## Comment on FTS CGMSAP dated Sept 18, 2009

GRU

February 12, 2010

**Figure 1. Locations of Surficial Aquifer wells proposed for sampling and redevelopment at the Cabot Carbon/Koppers Superfund Site.**

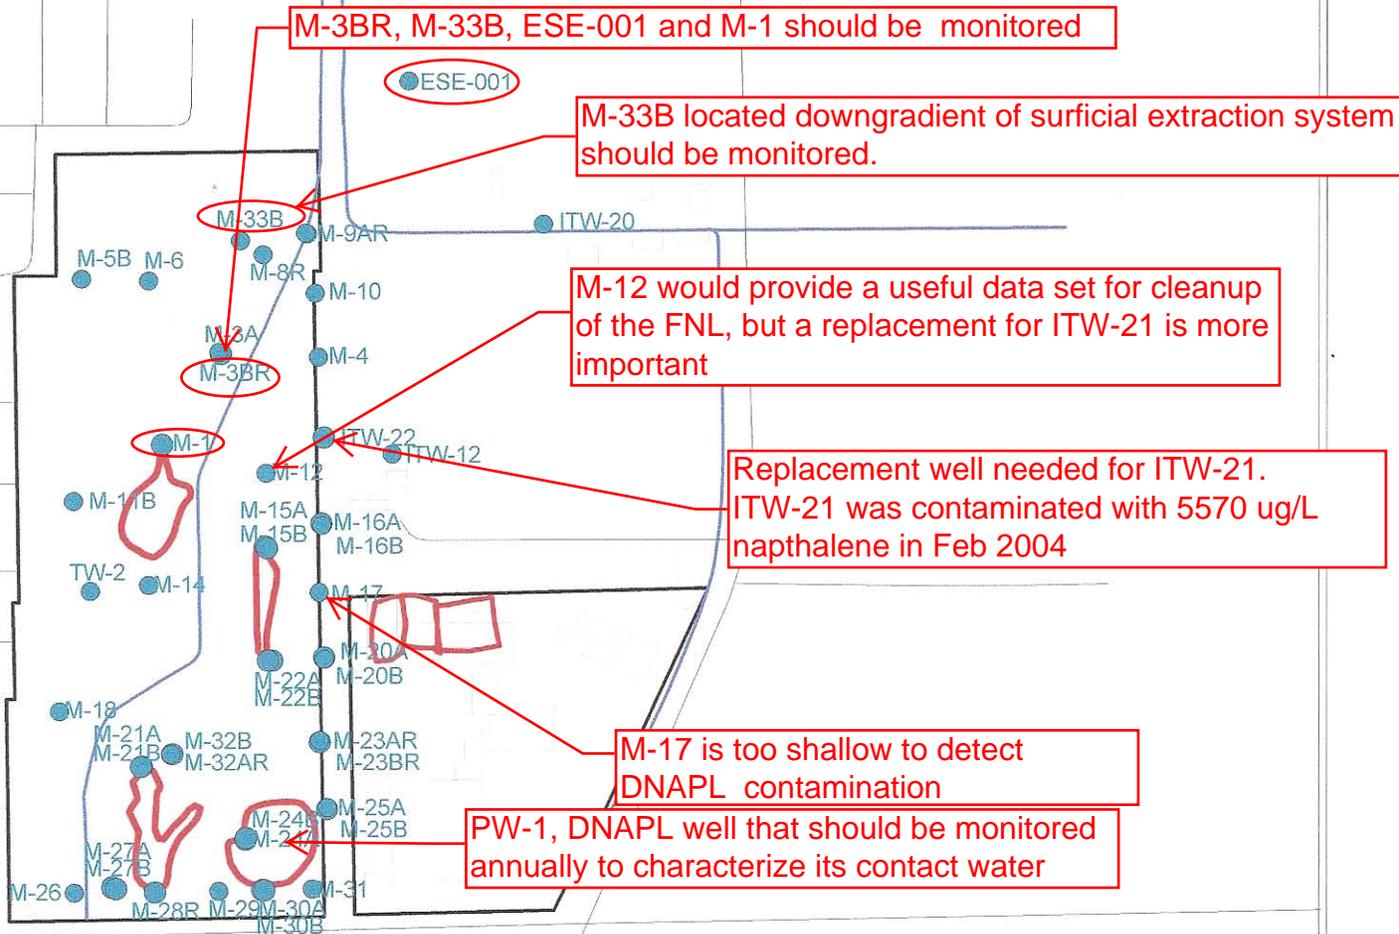
*GRU recommended in our comments dated December 3, 2008 that the CGMSAP include regular monitoring of five additional wells are M-1 [FNL], M-3BR [NE of FNL], M-12 [Former Drip Track], ESE-001 [off-site to the NE] and a replacement well for ITW-21 (ITW-21R), and PW-1. **Please see attached figure that shows the locations of those five MWs.** We see no reason to monitor ITW-12 and -22, once ITW-21R has been installed. The September 18, 2009 version of the CGMSAP does not include these wells. We believe that wells (ITW-12, ITW-21R), and M-33B should be added to the list. All surficial wells that are monitored should be sampled semiannually.*
